Community Engagement Key Findings Report -

Exhibition of draft Fairfield Village Built Form Guidelines & Heritage Assessment recommendations, September-October 2017

Objective Document ID Number	A4345970
Responsible Officer	Gilda Di Vincenzo
Custodians	City Design & Strategic Planning Unit
Date/s Issued and/or Communicated	27 November 2017
Version Number	1.1

AREA AND ISSUES RECOMMENDED TO BE COVERED IN A COMPREHENSIVE MASTERPLAN OF FAIRFIELD VILLAGE
(based on City of Darebin Draft Built Form Guidelines - Valued Street Facade Plan)

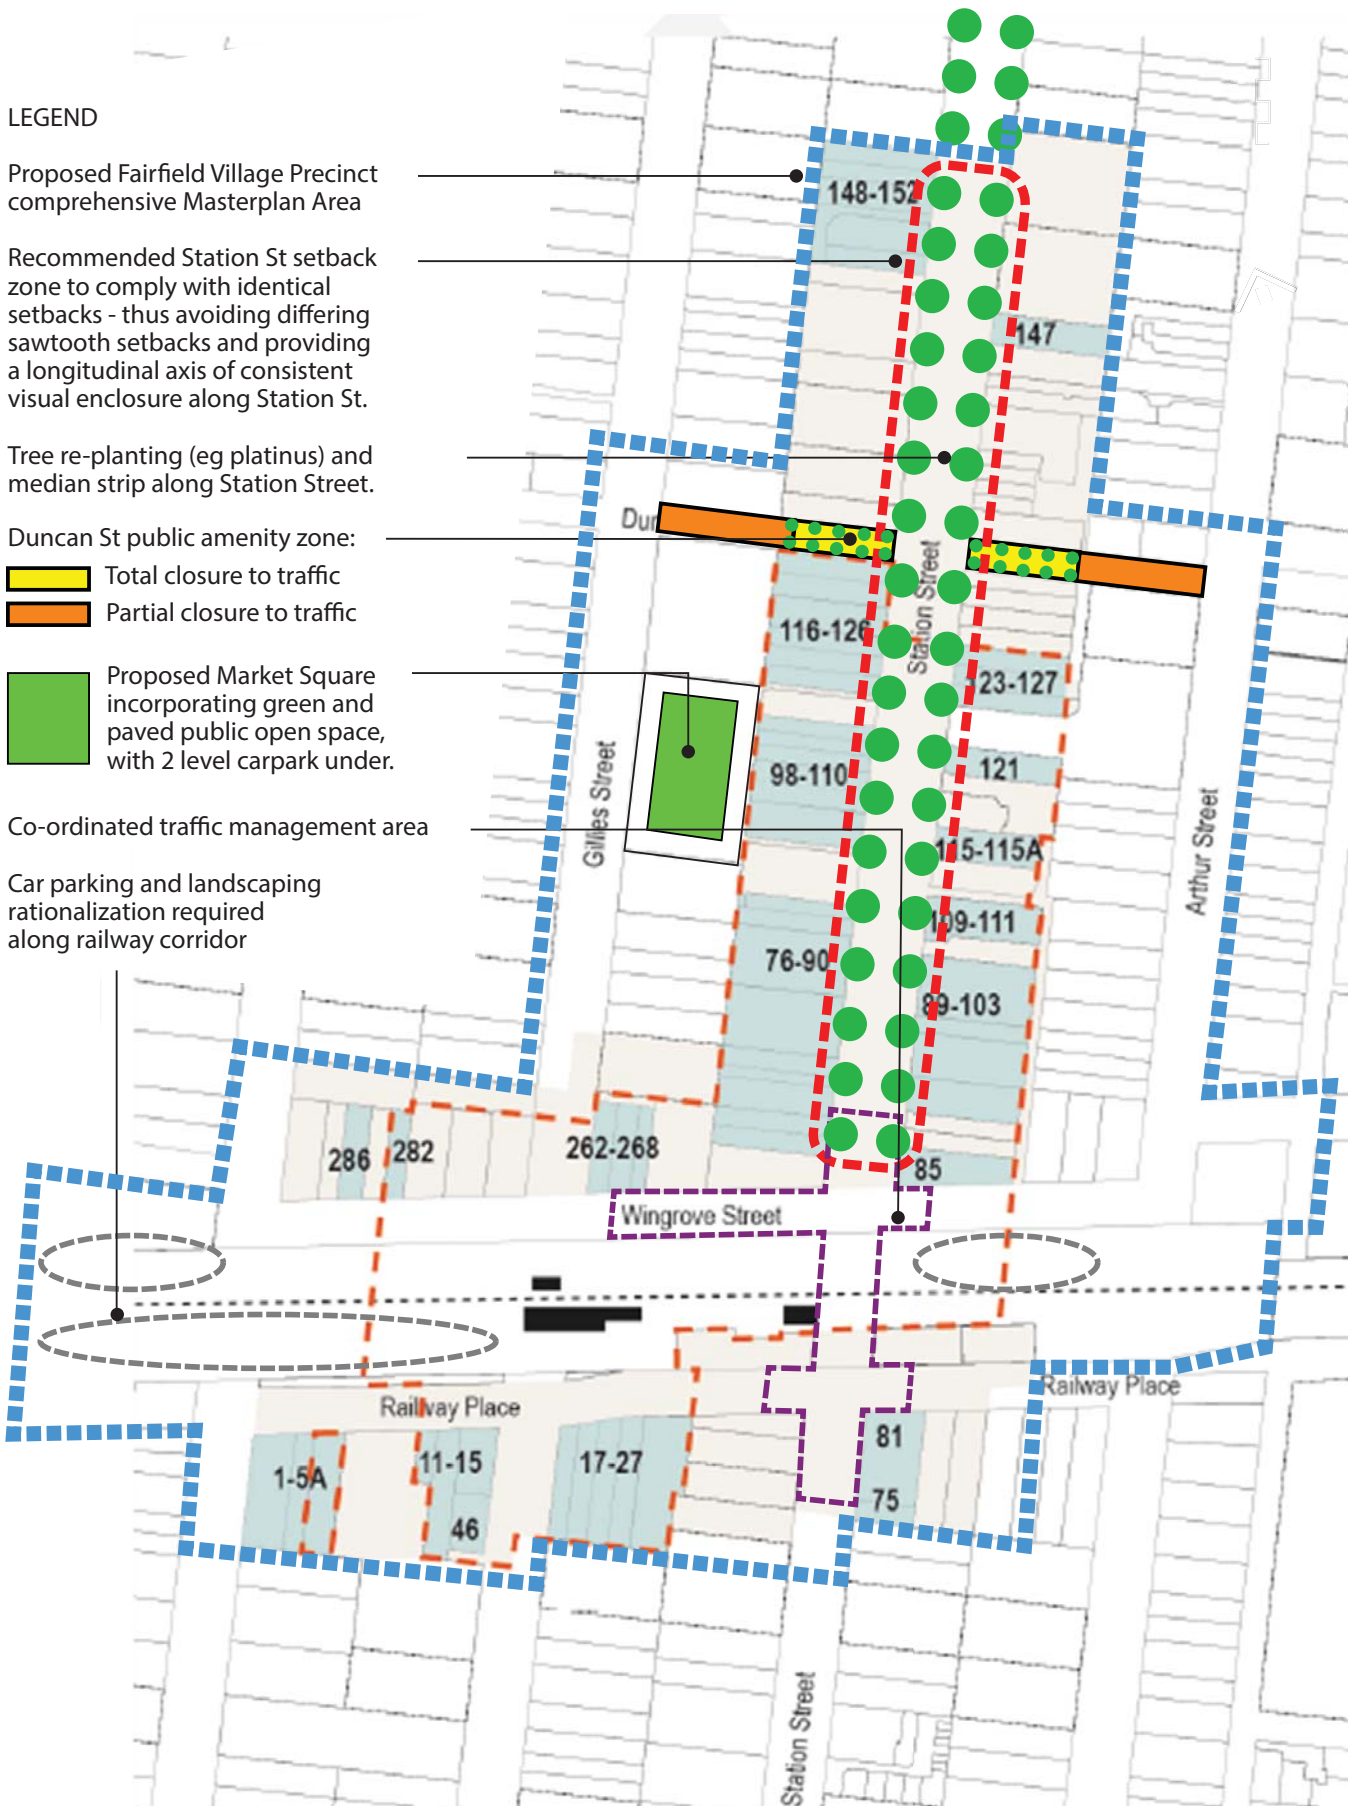
2) The definition and the boundaries for Fairfield Village need to include the Gillies Street car park. It is a part of many people's experience when accessing the Village. It is an ugly asphalt desert when empty and in busy periods it is also often full. There may be possibilities of increasing public open space here as well as providing extra car parking, thus 'killing two birds with one stone' by solving two of the major concerns identified in the Community Engagement Summary. (Refer drawing below)

Recommended Station St setback zone to comply with identical setbacks - thus avoiding differing sawtooth setbacks and providing a longitudinal axis of consistent visual enclosure along Station St.

Tree re-planting (eg platinus) and median strip along Station Street.

Duncan St public amenity zone:

- Total closure to traffic
- Partial closure to traffic

Figure 3.11. Map of the Fairfield Village Heritage Precinct developed and documented in Stage Two.

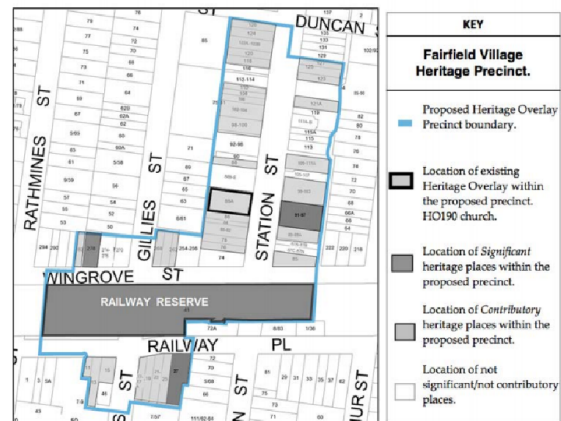
Introduction: 5 & 5a Railway Place Fairfield appears to be a late AND arbitrary inclusion in the Fairfield Village Heritage Precinct and the ASSOCIATED Heritage Assessment Report. The property does not appear in the Heritage Precinct Stage 1, nor the recommended amendments Stage 2 (see i below), nor the 'developed and documented' Fairfield Village Heritage Precinct Stage 2 (see ii below).

i. Recommended Amendments Stage 2

ii. Fairfield Village Heritage Precinct 'developed and documented' Stage 2.

<p>Our response</p>	<p>The submission was referred to the heritage consultant. She considers the submitters to have made valid points and provide good evidence to support their concerns, including details about physical changes made to the original front façade.</p> <p>It should be clarified that in preliminary findings of the heritage study, the consultant had recommended that the buildings at 1, 3 and 5-5A Railway Place <u>not</u> be included in the Fairfield Village heritage precinct on the basis that they were isolated from the Fairfield Village Heritage Precinct by the large RSL redevelopment. The integrity of the precinct would be compromised if it were to extend to include such a significant contemporary development.</p> <p>However, it was advised that a case could potentially be made for 5-5A Railway Place to be given an individual heritage overlay, should it meet the tests for individual significance. Based on the information available, the building appeared to meet these tests and was subsequently put forward as an individual site.</p> <p>The information now tendered by the owners about alterations and restorations to the original building fatally undermines the case for individual significance.</p> <p>On this basis the heritage consultant accepts that an individual heritage overlay should not be pursued. This is agreed. The final heritage assessment report will be updated to reflect new information and resulting decision.</p>

<p>Proposed changes</p>	<ul style="list-style-type: none"> • Update Fairfield Village Heritage Assessment final report to reflect revised assessment for 5-5A Railway Place and do not pursue heritage overlay controls for this site.

Figure 3.12. Detail diagram of the 'Village Square', Fairfield Village Heritage Precinct developed and documented in Stage Two.

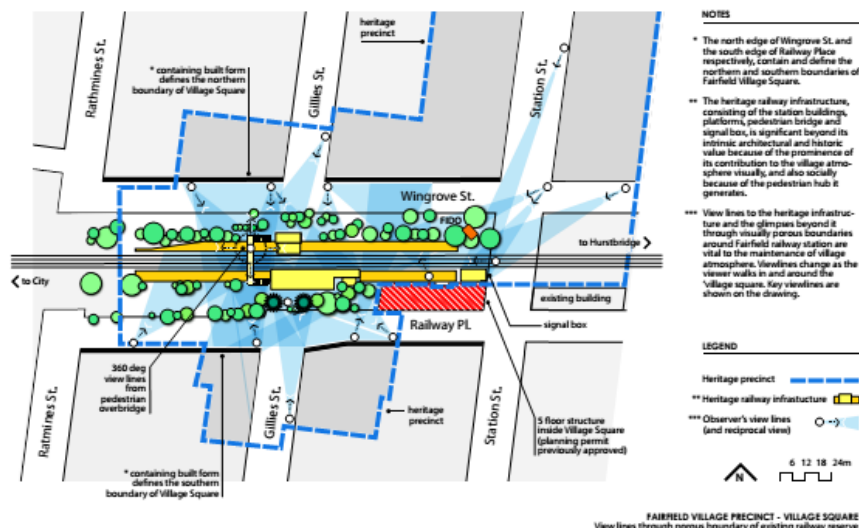
Neither is the property listed in the Fairfield Village Heritage Precinct 'Village Square' 'developed and documented' Stage 2 (see Figure 3.12 below).

5 and 5a Railway Place is assessed in the Fairfield Village Heritage Assessment Report (June 2017) as a '...a very intact interwar shop...'. The assessment appears to have missed or overlooked the very significant changes to the premises' façade in the last 40 years.
